ADDENDUM #5

Rye City School District

Osborn Elementary School

Midland Elementary School

PROJECT # D04-039-C DRAWING # S1

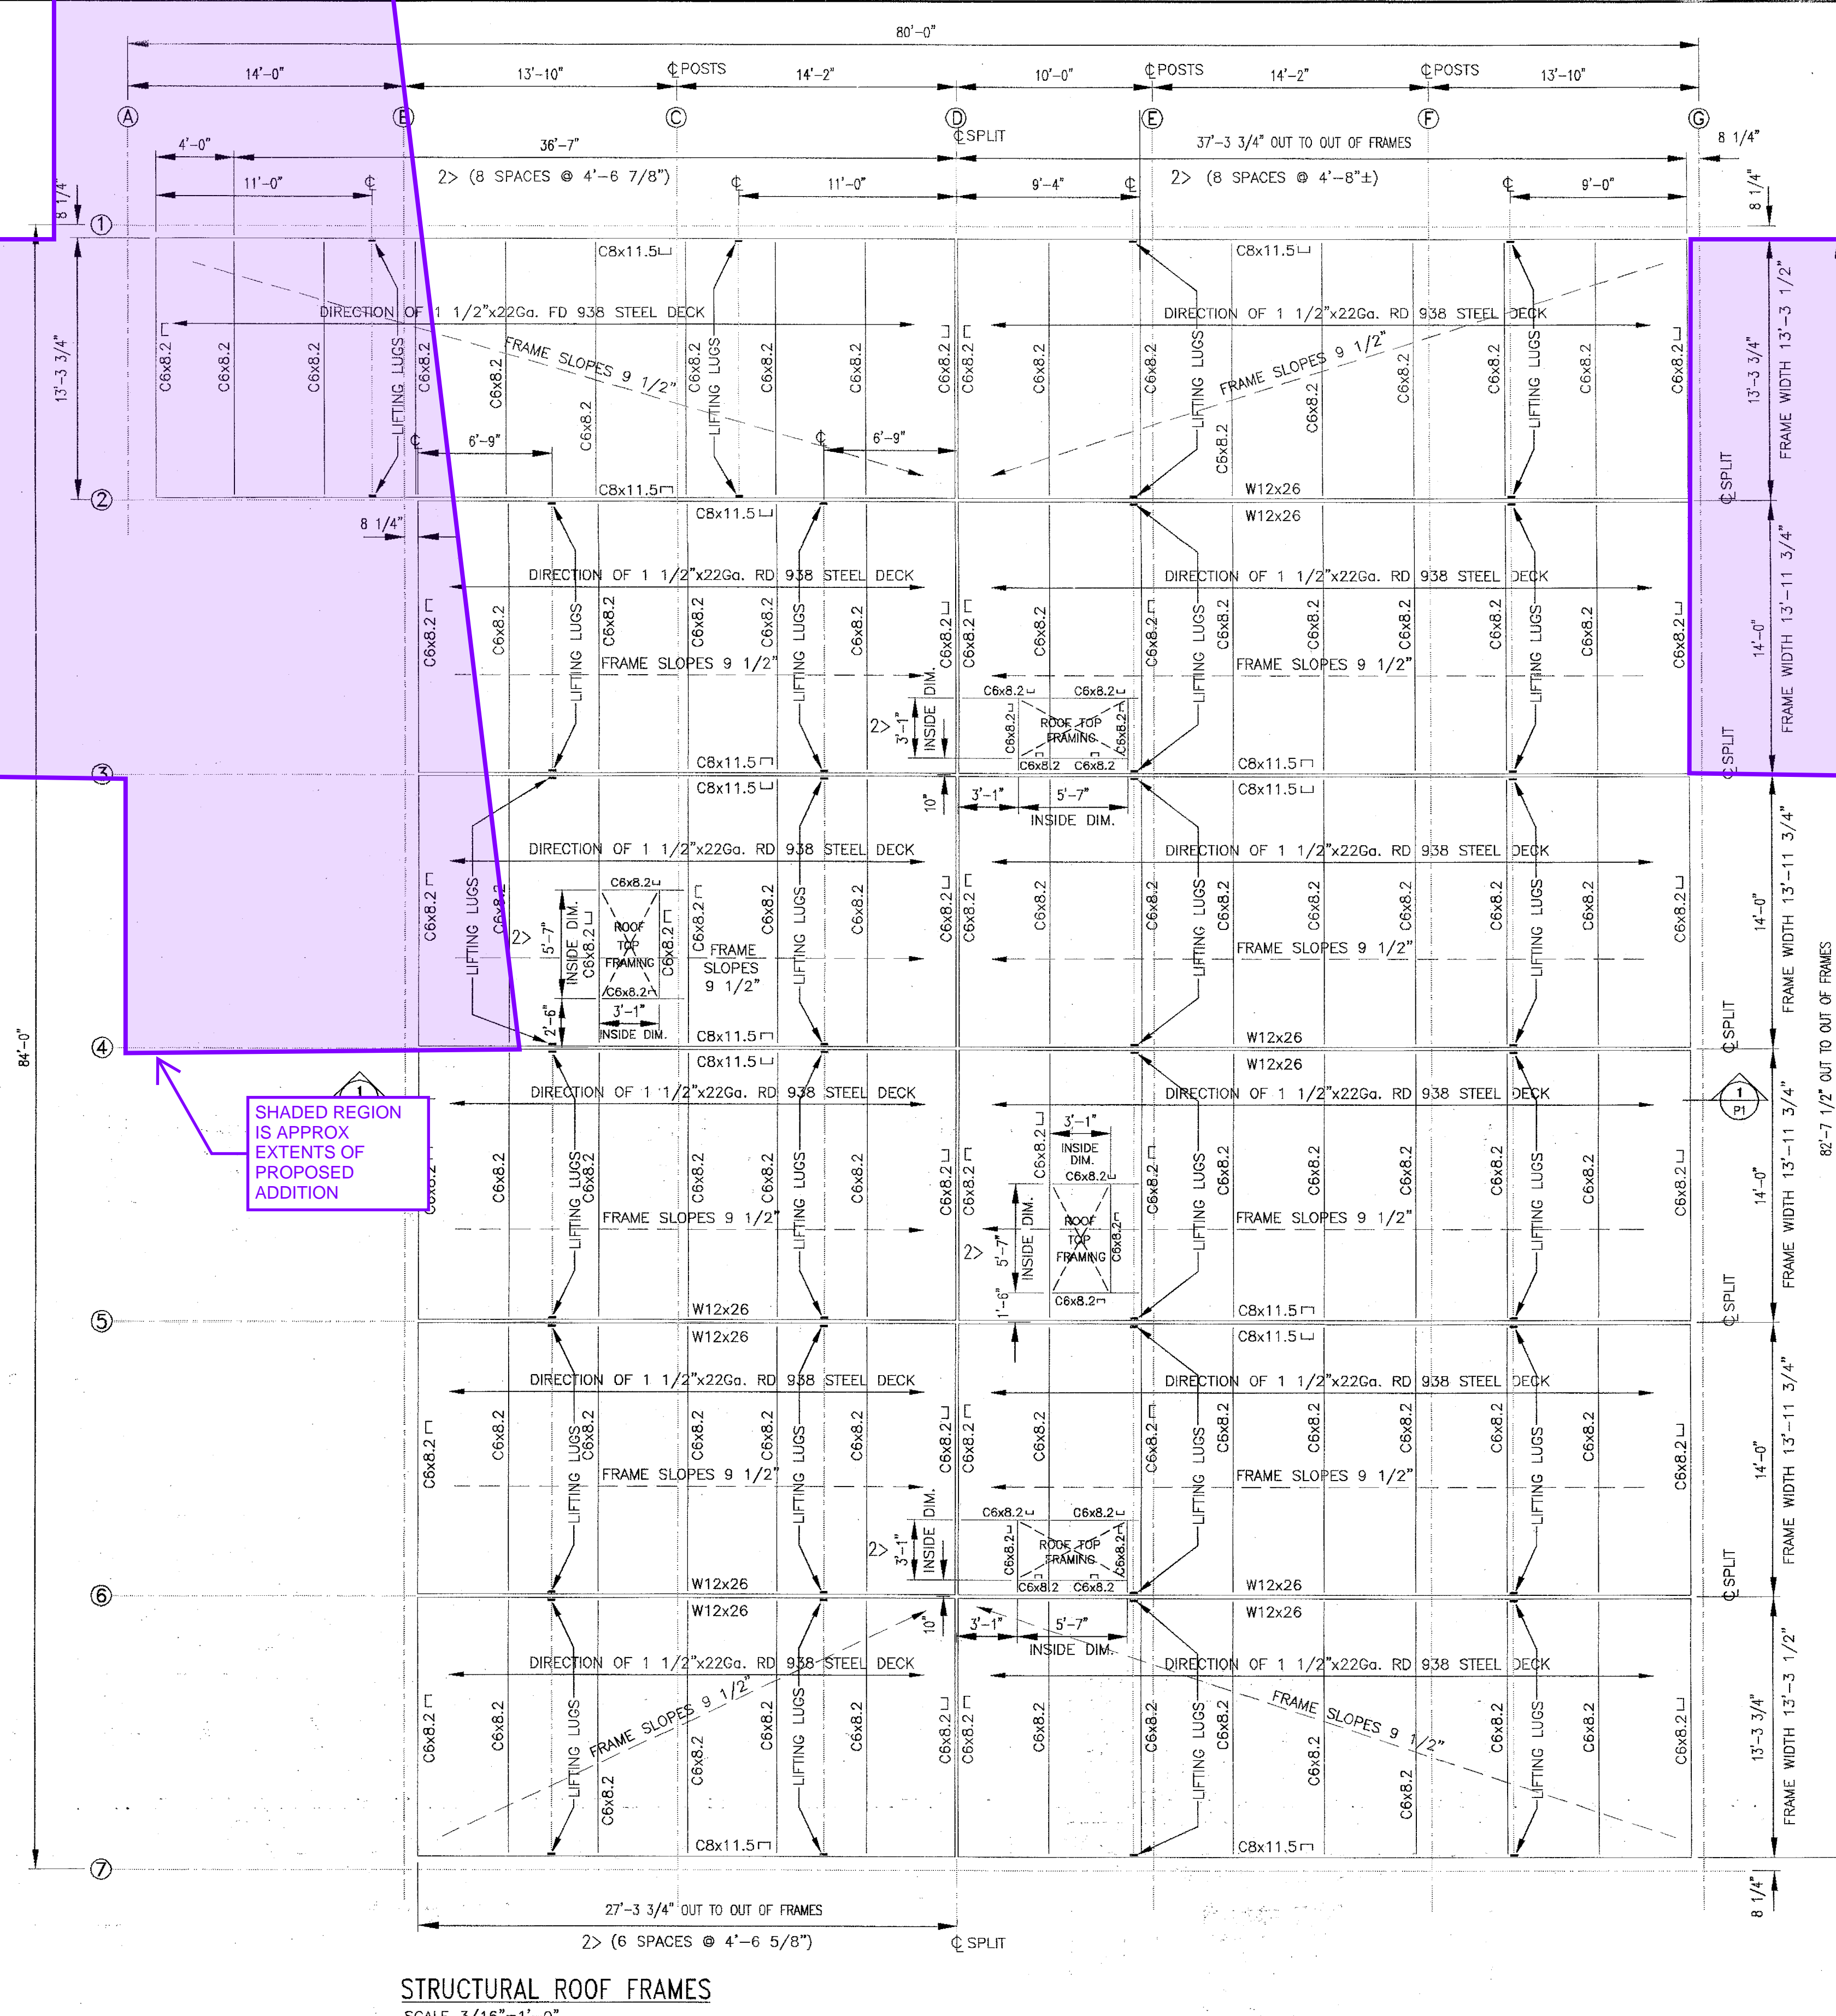
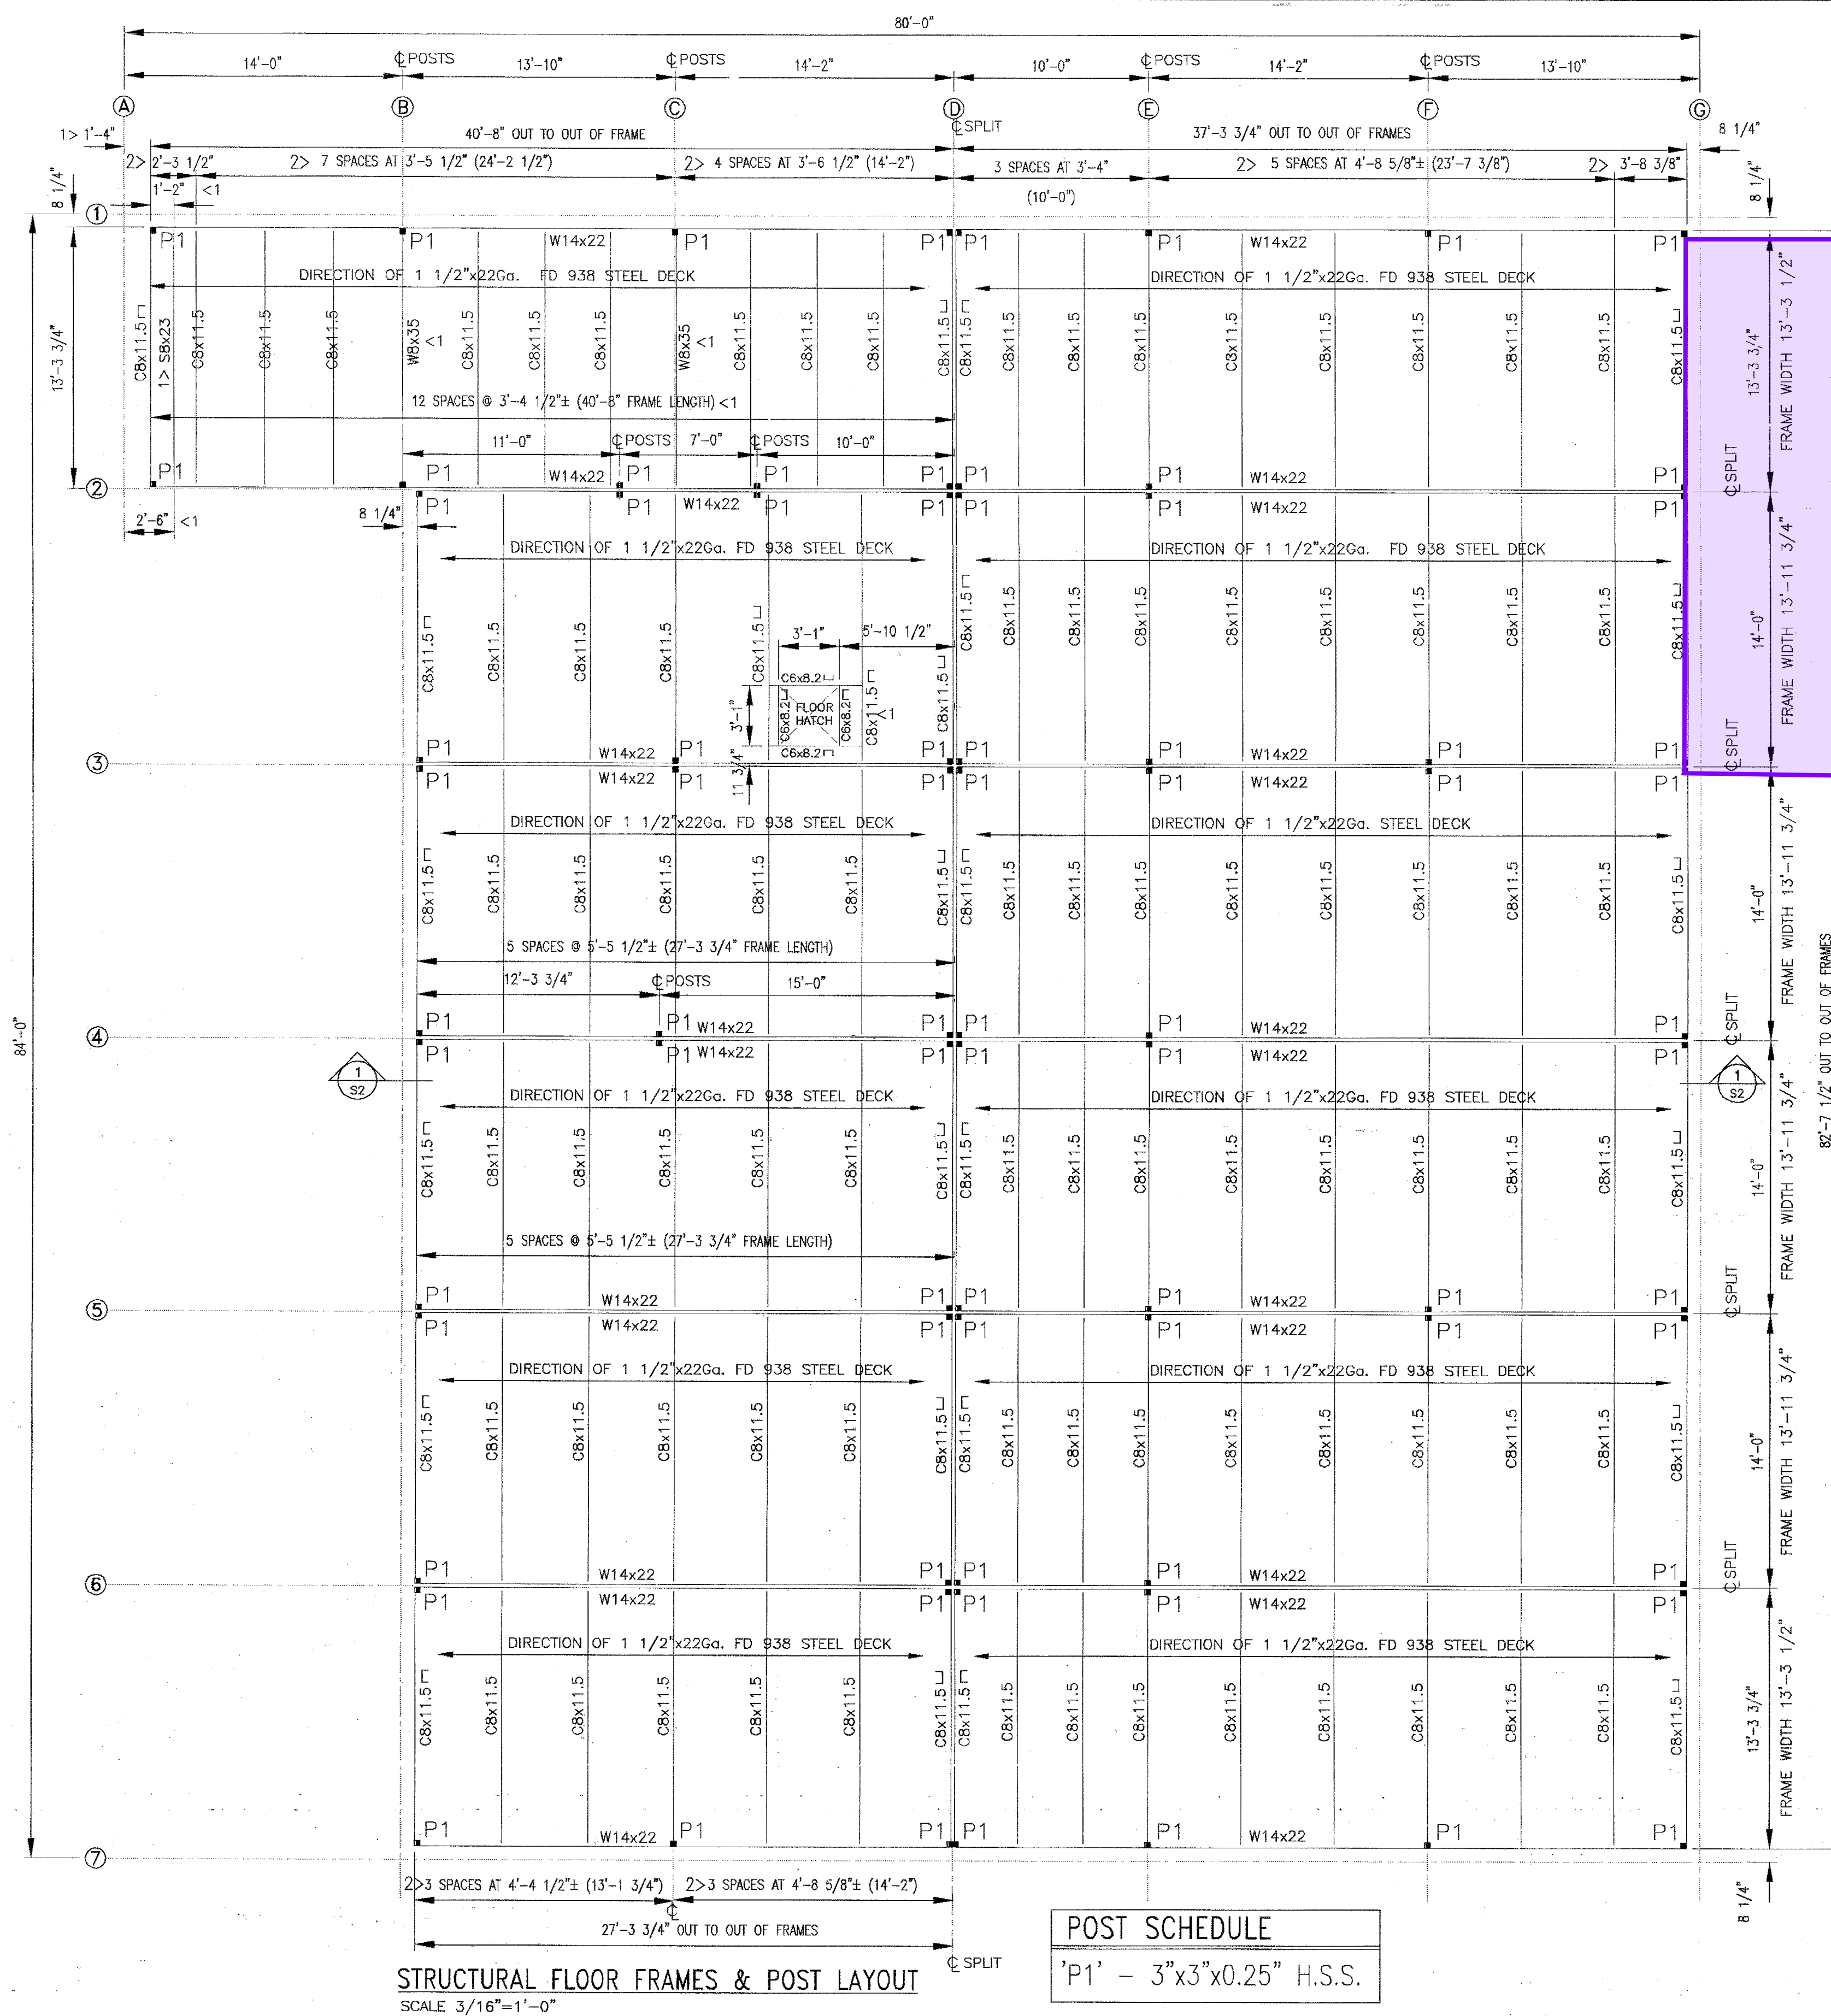
Additional reference regarding the framing of the existing building:

The proposed addition is going next to the 2005 addition. The original drawing package for this addition that shows the roof framing for the area adjacent to the proposed addition is provided in this addendum. These have been marked up to show where the proposed addition is in relation to the existing building to assist and clarify with estimating required fireproofing.
